TECHNICAL SERVICE BULLETIN

Classification:	Reference:	Date:
EC26-013	ITB26-006	May 21, 2026

ENGINE NO START WITH KEY SYSTEM ERROR AND DTC B2C20-24 STORED IN THE BCM

APPLIED VEHICLES: 2026 QX60 (L51)
APPLIED DATES: AWD built on or before September 4, 2025
 FWD built on or before September 8, 2025

Figure 1

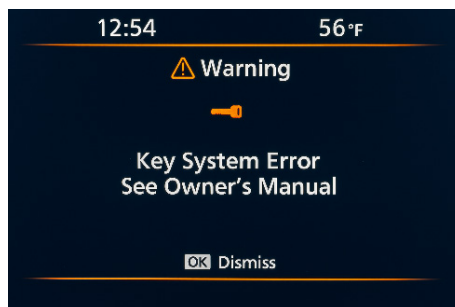
The customer states the engine will not start and "Key System Error" warning is displaying in the Information Display (Combination Meter) (Figure 1),

HINT: This DTC and warning message (Figure 1) may occur if the customer does not place the vehicle in Park Gear according to the Owner's Manual for shifter operation.

1. Confirm the current ECM part number.
2. Confirm the current TCM part number.
3. Reprogram the ECM, and then the TCM, if applicable.
4. Erase the DTCs.
